HISTORIC AND DESIGN REVIEW COMMISSION

April 07, 2021

HDRC CASE NO: 2021-133
ADDRESS: 520 LEIGH ST
LEGAL DESCRIPTION: NCB 2739 BLK LOT 4F & PT OF 5F (AKA TRACT 6)
ZONING: IDZ,H
CITY COUNCIL DIST.: 1
DISTRICT: Lavaca Historic District
APPLICANT: Scott Jones/LABOR STREET COMMONS LLC
OWNER: Scott Jones/LABOR STREET COMMONS LLC
TYPE OF WORK: Construction of a multistory residential structure, site modifications
APPLICATION RECEIVED: March 17, 2021
60-DAY REVIEW: Not applicable due to City Council Emergency Orders
CASE MANAGER: Stephanie Phillips

The applicant is requesting a Certificate of Appropriateness to construct a new 2-story single family residence at the lot addressed 520 Leigh St.

4 **Standalone Residence-North Elevation**
3/16" = 1'-0"

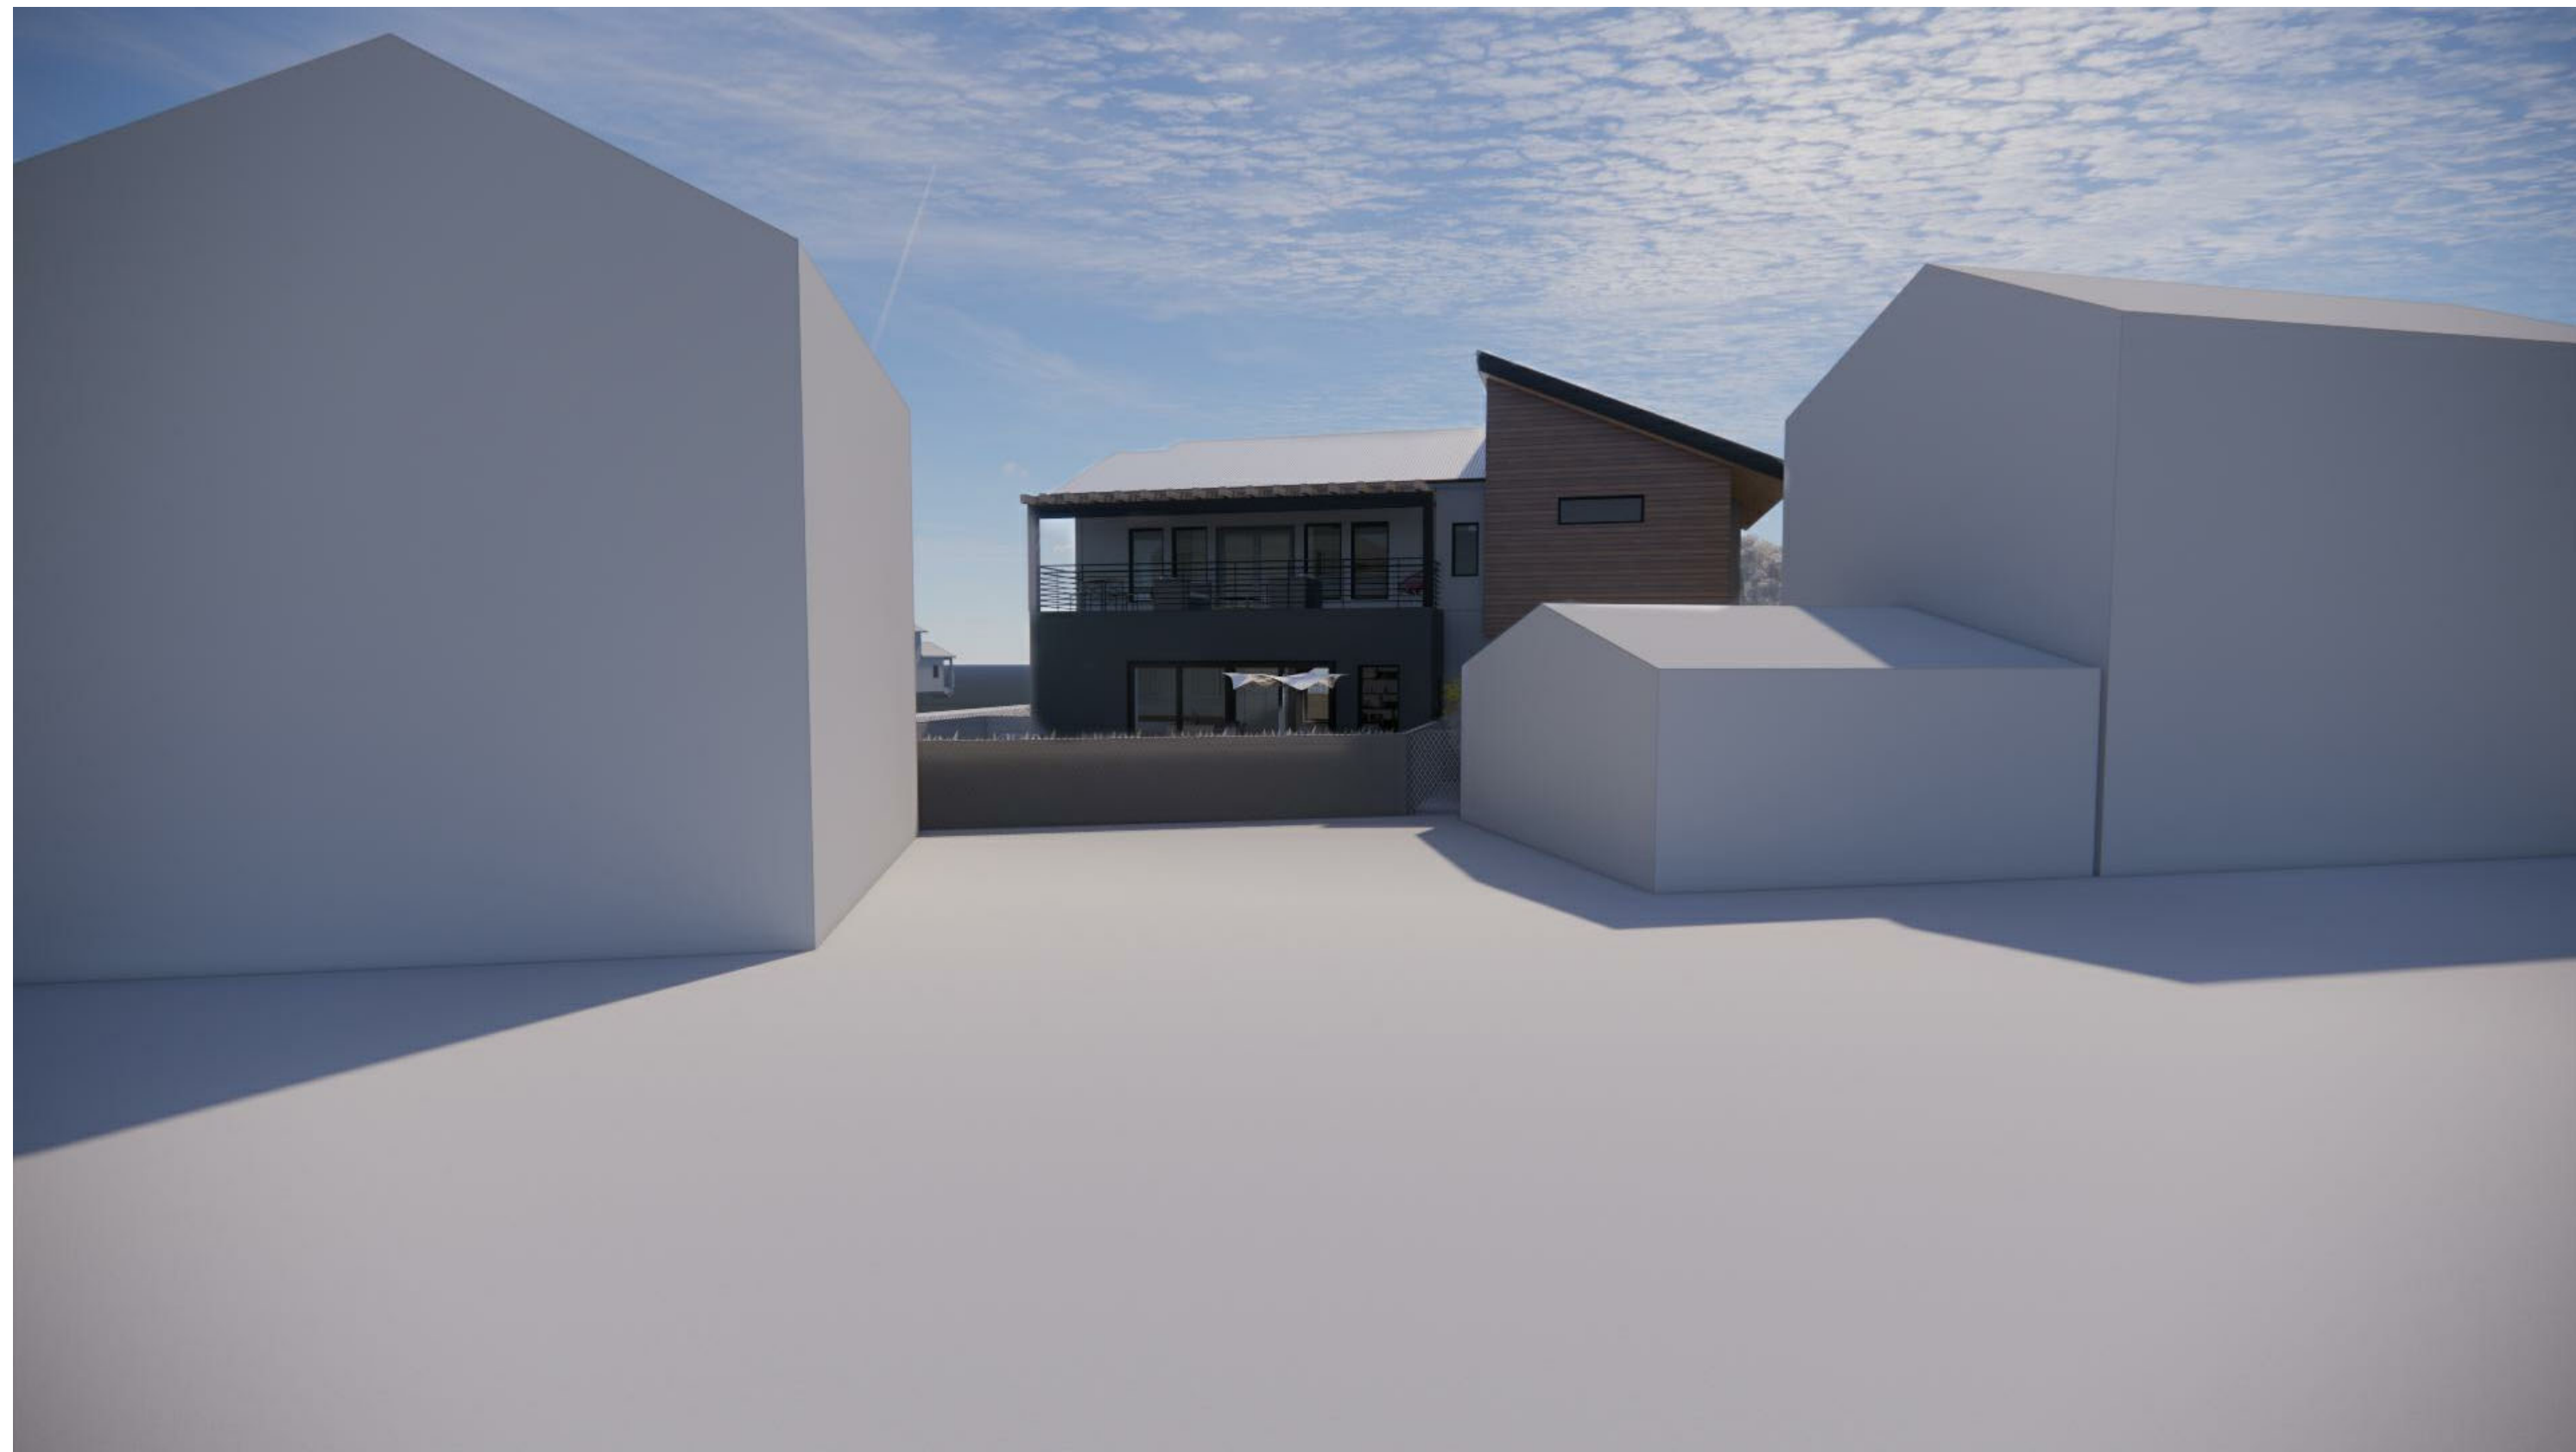
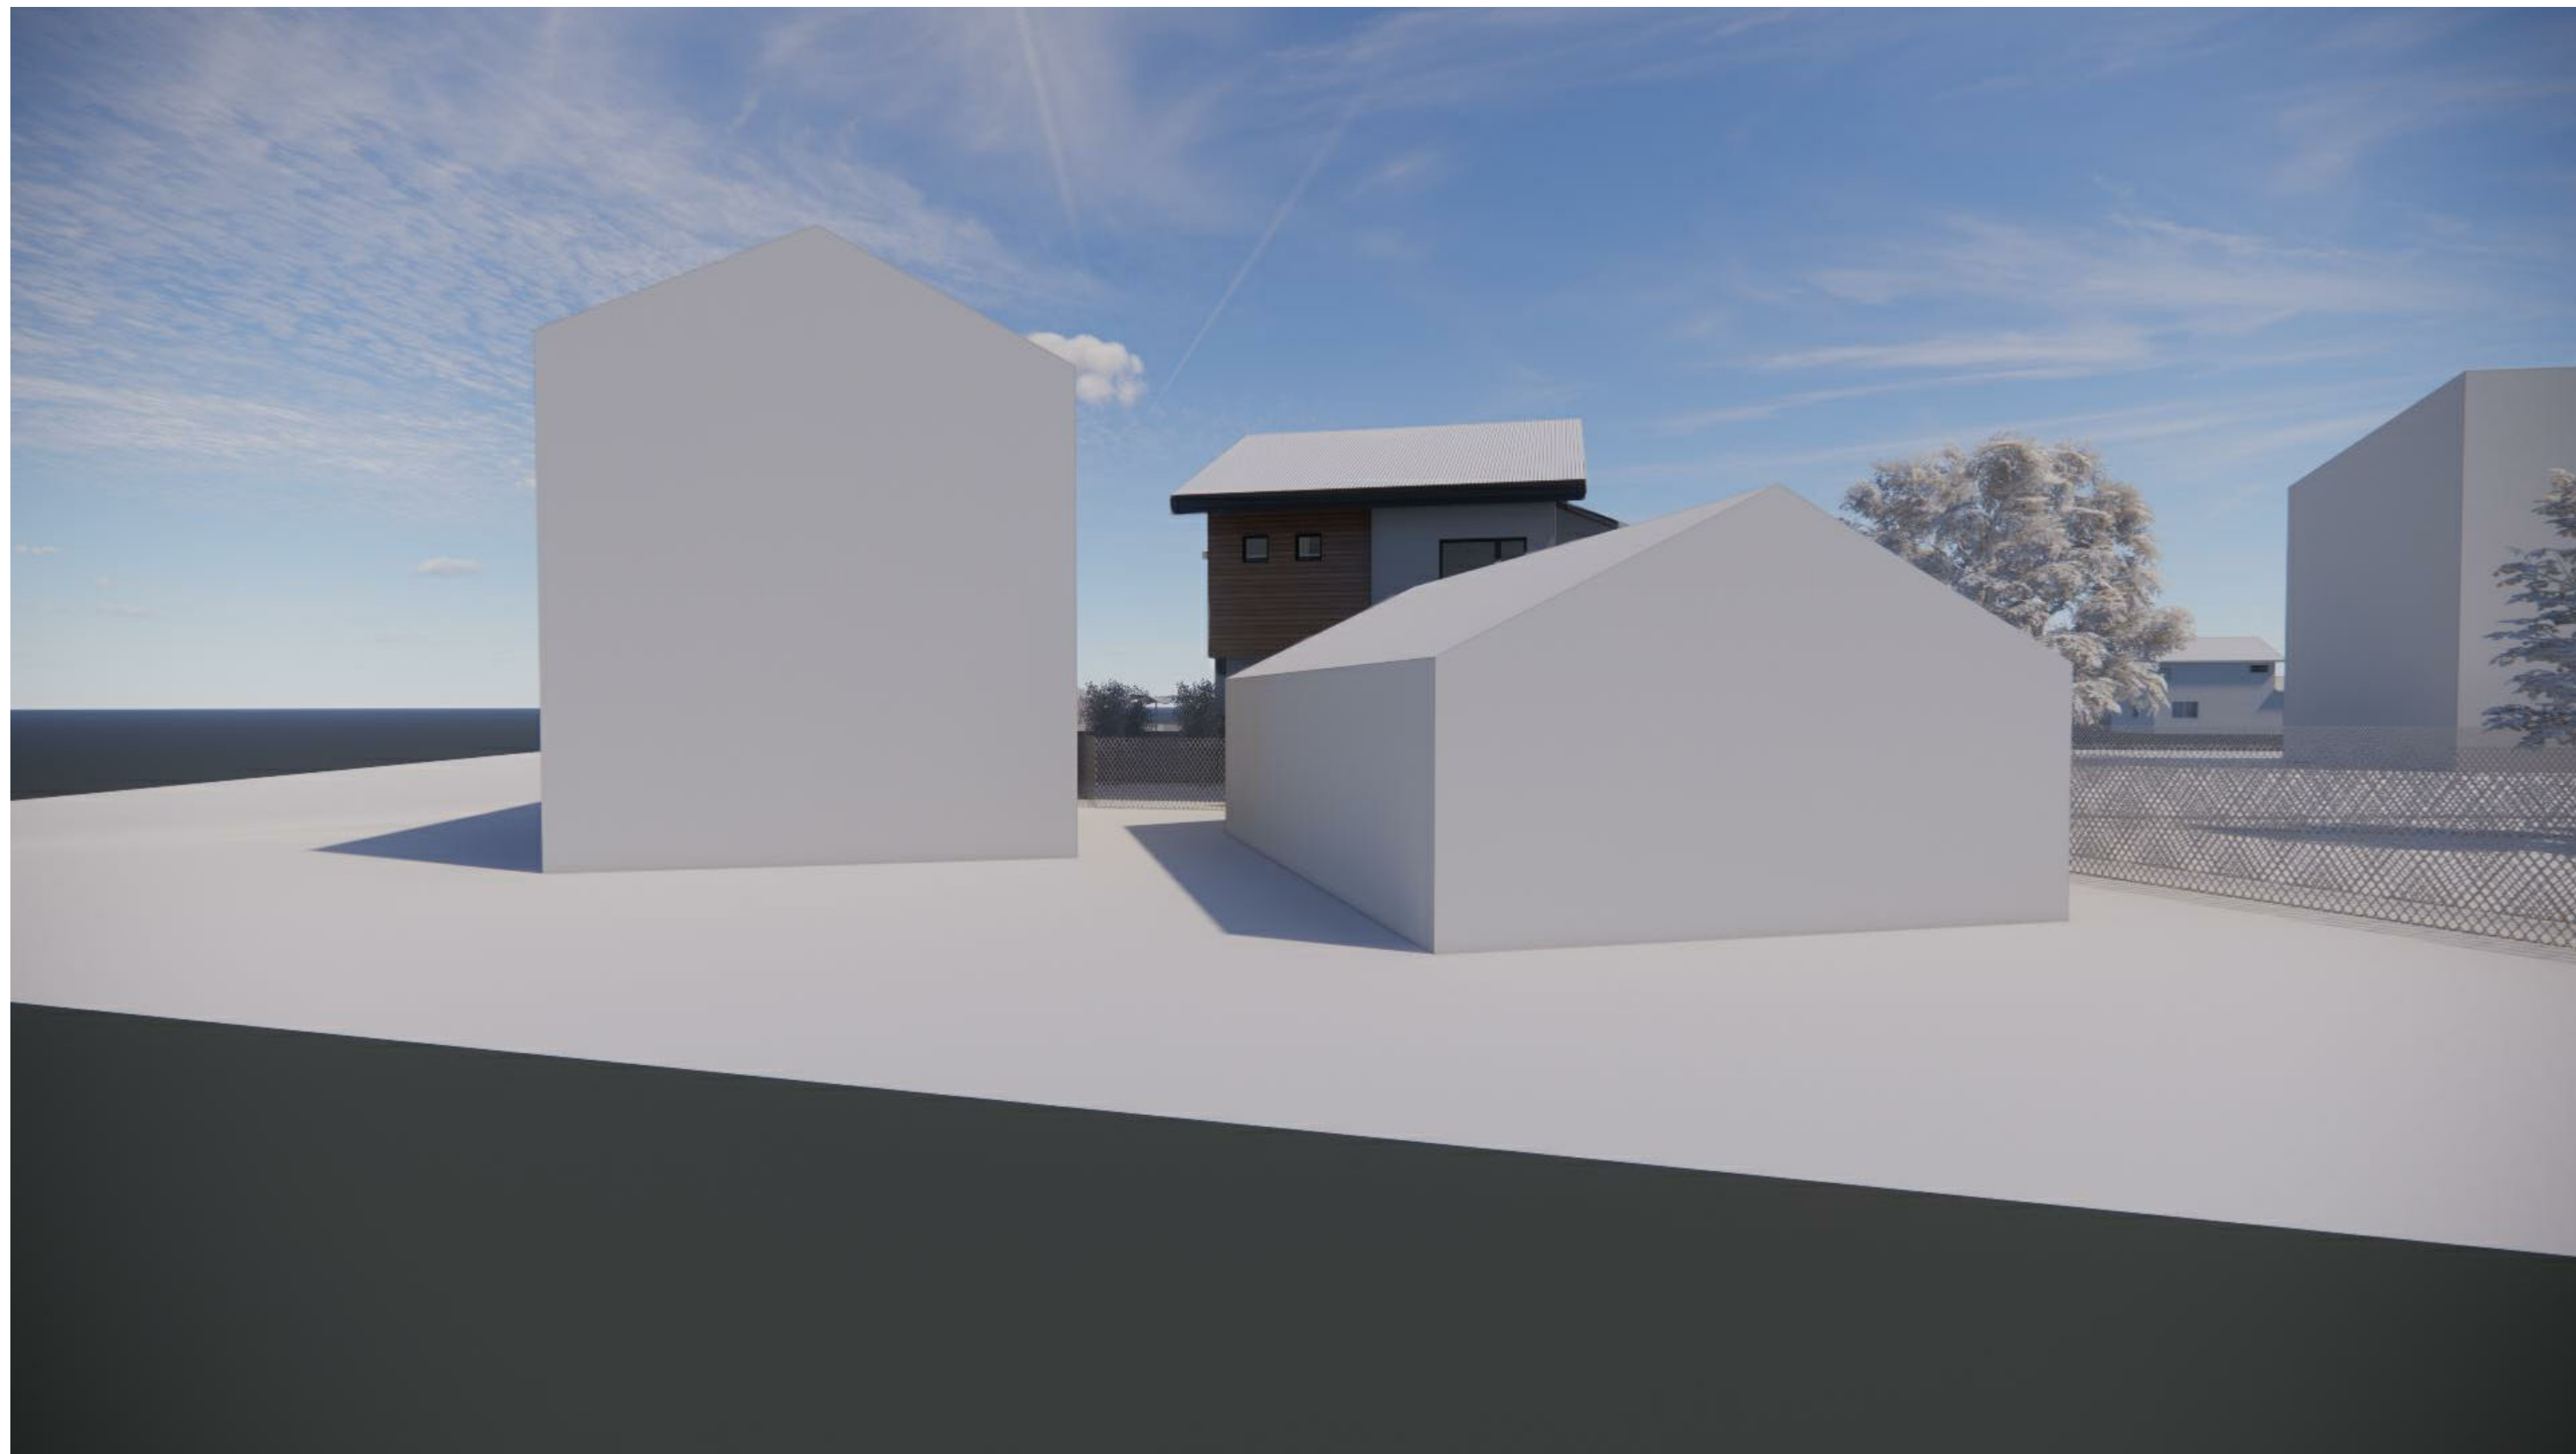
- j. FOUNDATION & FLOOR HEIGHTS – Per the Guidelines for New Construction 2.A.iii., applicants should align foundation and floor-to-floor heights within one foot of floor-to-floor heights on adjacent historic structures. Based on the submitted elevations, the proposed foundation is slab-on-grade with a minimal rise. Staff finds that the applicant should utilize foundation heights that are consistent with the Guidelines.

- k. ROOF FORMS – The applicant has proposed a multi-slope roofline. The primary roofline is a side gable with a low-sloping shed roof extending to the north. . Staff generally finds these roof forms to be consistent based on the surrounding context, but finds that in context with the proportions of the home, additional roof solutions should be explored to visually reduce the mass of the flat roof portion, primarily on the north and east elevations.

- l. WINDOW & DOOR OPENINGS – Per the Guidelines for New Construction 2.C.i., window and door openings with similar proportions of wall to window space as typical with nearby historic facades should be incorporated into new construction. Per the elevations that the applicant has submitted, staff finds the proposed windows to be inconsistent with the Guidelines. The proposed sizes, configurations, and rhythm are not found historically within the district.

- p. WINDOW MATERIALS – The applicant has proposed aluminum clad wood windows, which may be consistent with staff’s stipulations. However, the proposed windows in terms of pattern, detailing, configuration, proportion, and inset are not consistent with the Guidelines.

- i. That the proposed structure be reduced in height and massing to be consistent with rear accessory structures found historically within the district (subordinate to primary structures), as noted in findings f and g.
- ii. That the applicant utilize foundation heights that are consistent with the Guidelines, as noted in finding i.
- iii. That the applicant incorporate roof forms that are more consistent with the surrounding historic context as noted in finding j.
- iv. That the applicant incorporate appropriate traditional window sizes and proportions and modify the overall fenestration pattern as noted in finding k.
